M1070P1
HET Tractor...

Remove the Rub

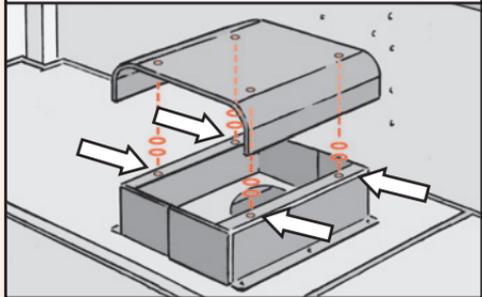
Mechanics, you need to do a little modification to the armor kit installed on M1070P1 HETs to prevent damage to the CTIS manifold under the driver's seat.

There's not enough clearance between the manifold and the armor plate. The two vibrate and rub against each other until the manifold finally fails.

1. Remove the driver's seat following the instructions starting on Page 16-54 of TM 9-2320-360-20-2.
2. Remove the armor panel. See Fig 3-88 in TB 9-2320-360-13&P-2 for help.
3. Install two flat washers, NSN 5310-00-081-4219, on top of each of the seat support's four mounting holes.
4. Reinstall the armor plate using new locking nuts, NSN 5310-00-814-0673.
5. Reinstall the driver's seat.

Put two flat washers on each mounting hole between armor plate and seat support

The washers provide enough clearance between the armor plate and the CTIS manifold to prevent the rubbing problem.
